# Horsley Witten Group

February 13, 2018

Re: Proposed Abbyville Commons Development in Norfolk, MA – Comments on Hydrogeologic Topics

Figure 2. Revised  
Bedrock Elevation  
Contours.

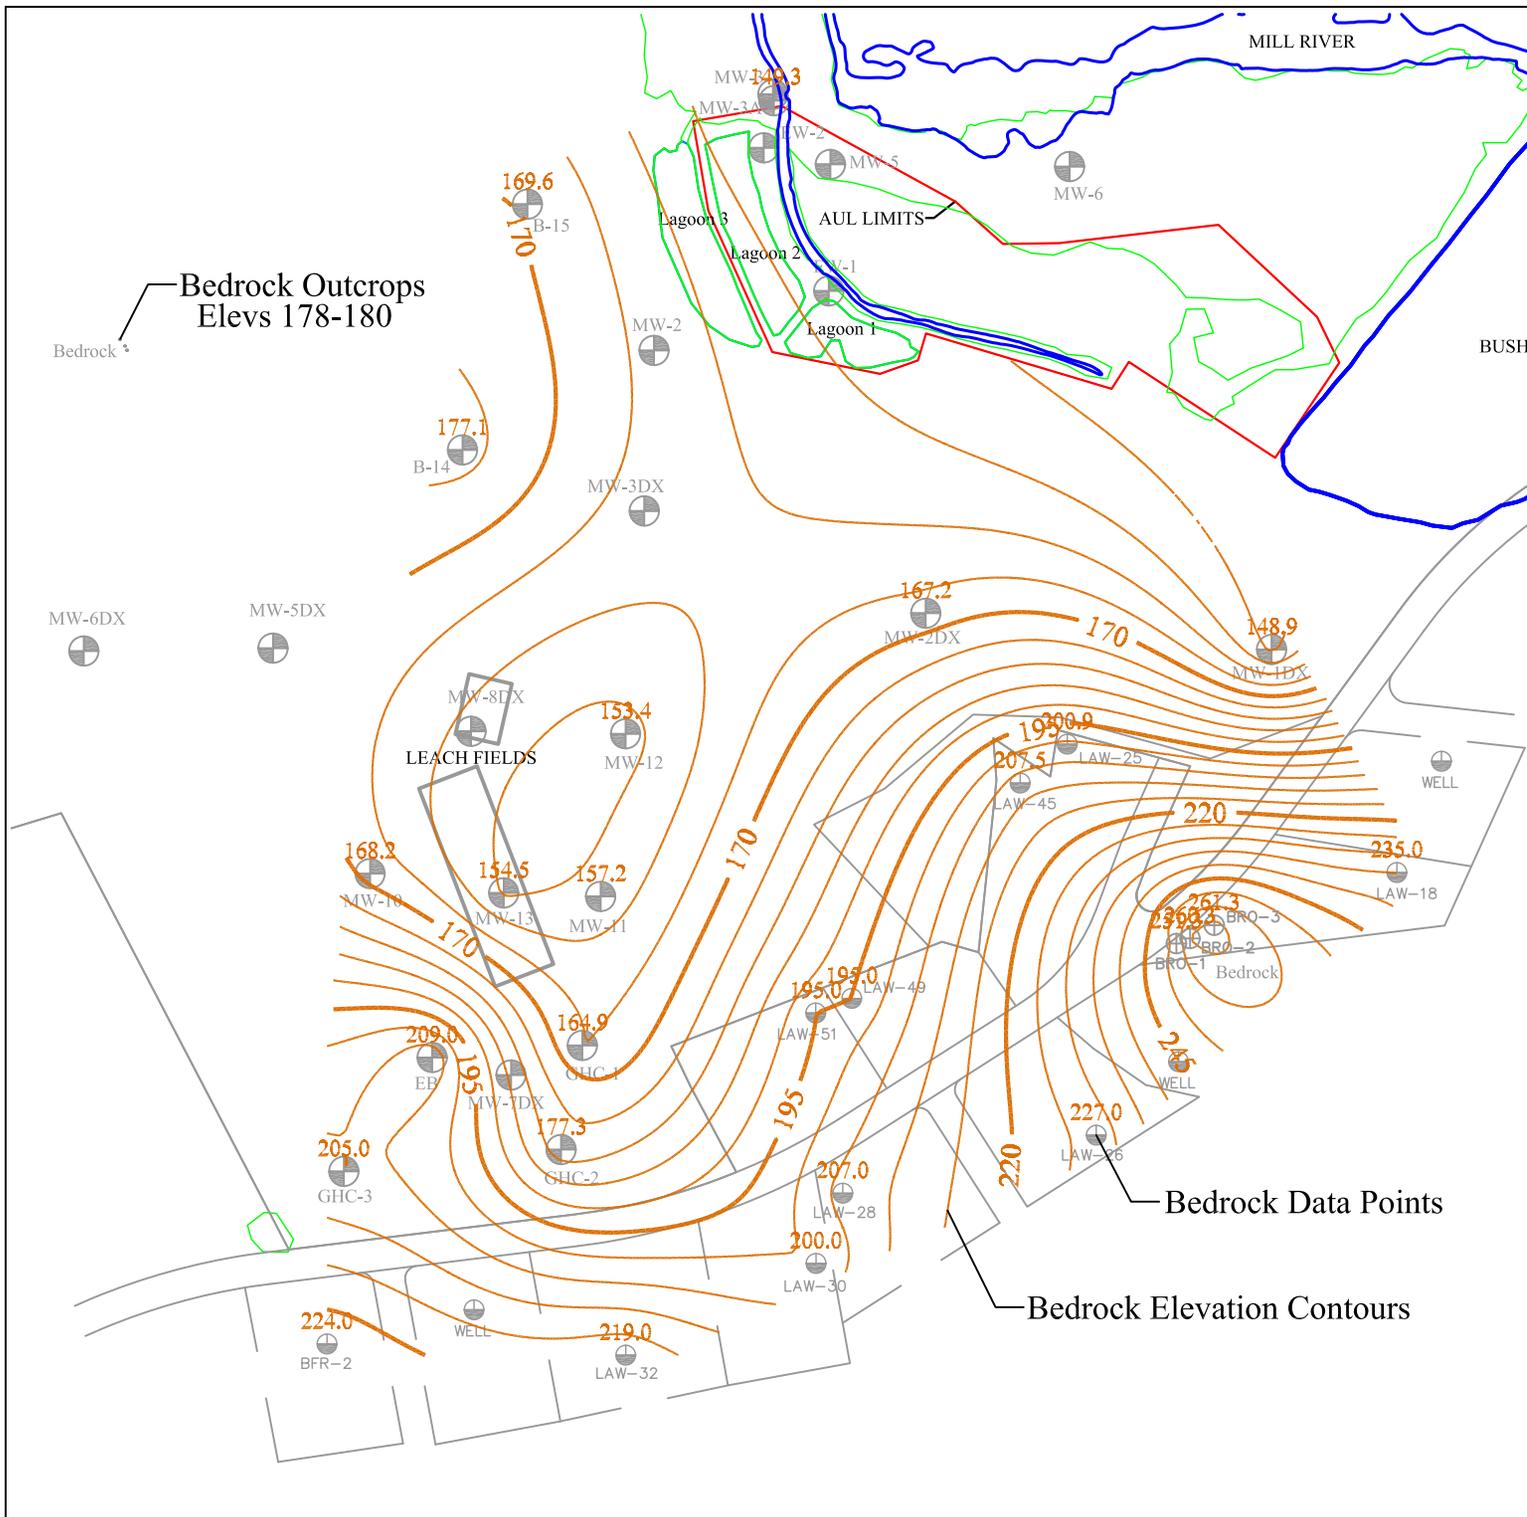
On February 5, 2018 the Applicant submitted supplemental data based on bedrock elevations from other monitoring wells on site not reported in the Hydrogeologic Report and nearby private drinking water wells. Figure 2 from that letter depicts a revised bedrock elevation map based on that larger set of bedrock data. Because private well bedrock elevations were calculated by subtracting from estimated ground surface elevations, those bedrock elevations are likely accurate to plus or minus five feet. For the purposes of this analysis that level of accuracy does not change any conclusions.

The revised Figure 2 presents a more compelling case for the proposed WWTF to be located in a bedrock valley. Certainly the additional bedrock data from the private wells presents strong support for a bedrock high to the southeast that would minimize the potential for groundwater flow from the proposed WWTF in an east/southeasterly direction (towards Lawrence Street) in unconsolidated aquifer sediments. The support for a bedrock high to the northwest is less strong with only two additional wells encountering bedrock, and only one of those encountering bedrock at an elevation above 170 feet. Therefore the effectiveness of bedrock high points for hydraulically isolating the WWTF plume from sensitive receptors to the northwest is still uncertain.

submitted by the Applicant on February 5, 2018 and depicted in Figure 2 in that letter provides further support that groundwater from the proposed WWTF would be unlikely to flow towards Lawrence Street, at least through surficial sediments. In addition, the fact that all of the Lawrence Street private wells are deep bedrock wells suggests that there is unlikely to be significant saturated groundwater in unconsolidated sediments above the bedrock surface in the Lawrence Street area.

Figure 3

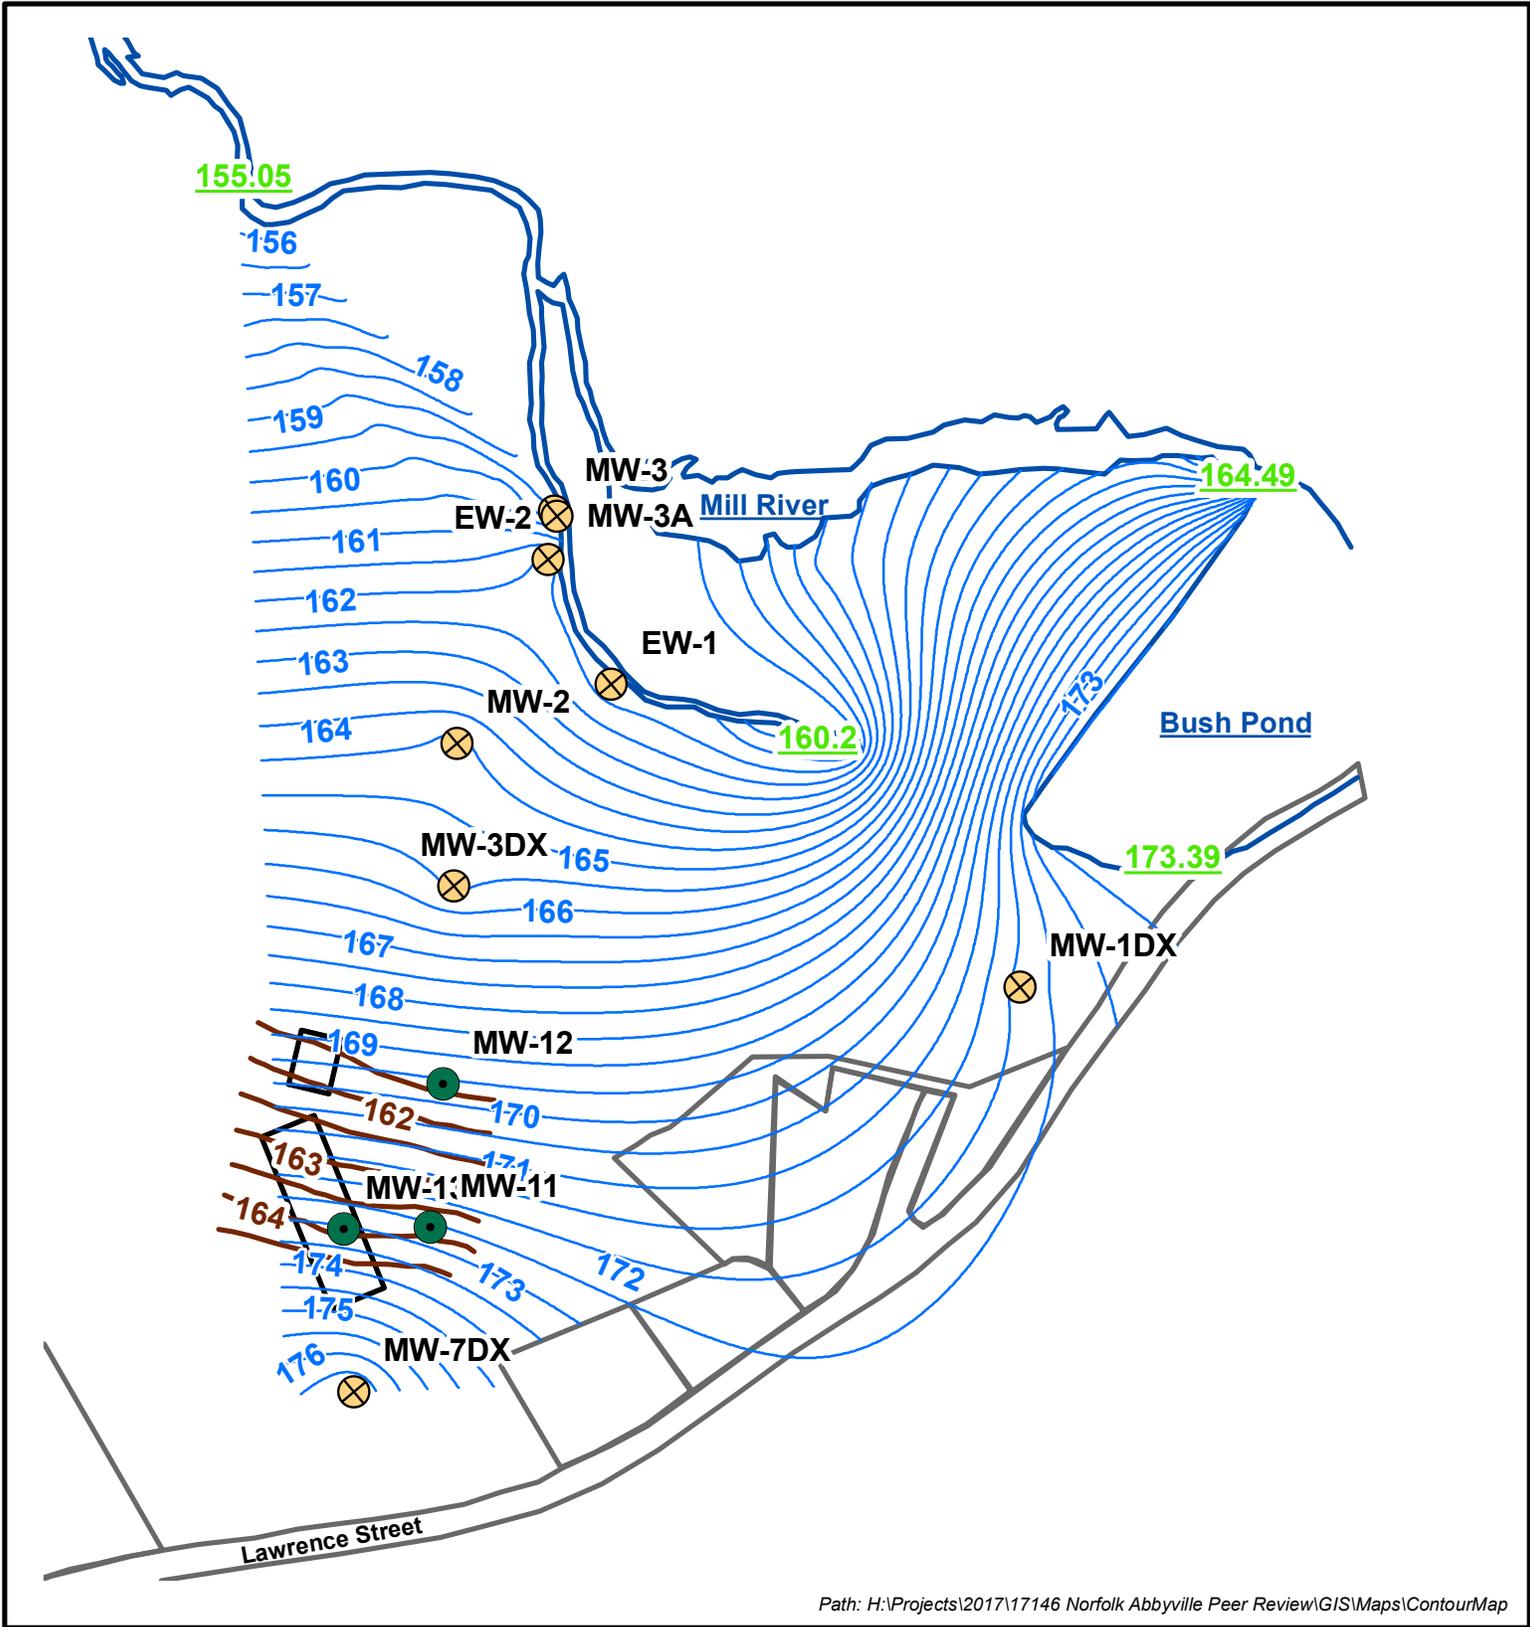
The results of the HW groundwater mapping effort are included here as Figure 3. The HW-generated contours using groundwater data from April 2, 2015 are overlain on top of the GHC-generated November 15, 2017 groundwater map to compare the two maps. The figure shows that while the generalized groundwater flow direction is similar between both maps showing flow heading northeast towards the river, because the April 2, 2015 map includes more data points spread over a larger area, it shows a more nuanced and detailed flow field. Groundwater flow originating in the area of the proposed WWTF is shown to begin with a slightly more easterly component and then wrap around to include a slightly more northwesterly component before terminating at the Unnamed Trench and the Mill River.

This groundwater flow mapping comparison is intended not to say that one is correct and the other not; but simply to demonstrate that subtle differences in mapping can emerge based on how many wells are used, which wells are used, and even the time from which data were collected. And those subtle differences in mapping can affect how one evaluates the potential for groundwater impacts to sensitive receptors. Neither groundwater contour mapping dates should be considered complete or conclusive. More data would lead to still more reliable mapping. The April 2, 2015 groundwater contouring suggests a flow path that might take groundwater recharged at the proposed WWTF closer to the private wells on Lawrence Street than what is depicted based on the November 15, 2017 contours, but still not likely to actually reach those wells. The more northwesterly wrapping of the down-gradient portion of the flow field shown based on the April 2, 2017 contours does suggest a greater chance for influence from the proposed WWTF on the Town Test Well Site than is suggested by the November 15, 2017 contours.

Also of note on Figure 3 is that the depicted water table elevations are substantially higher for the April 2, 2015 data than for the November 15, 2017 data. In fact the April 2, 2015 water table elevations in the vicinity of the proposed WWTF are similar to the seasonal high groundwater (SHGW) water table elevations depicted in Figure 6 of the Applicant's February 5, 2018 supplemental data submittal. Part of the difference is simply that the water table was higher in April of 2015 than it was in November of 2017. But based on data from a nearby USGS Index Well (MA-NNW 27) April 2015 groundwater levels were still lower than SHGW. It is possible that there was a measurement error from MW-7DX in the April 2, 2015 data. That is the only well from that April 2, 2015 data set in the immediate proximity of the proposed WWTF and, therefore, its data dominantly influences the water table contours generated for that area.
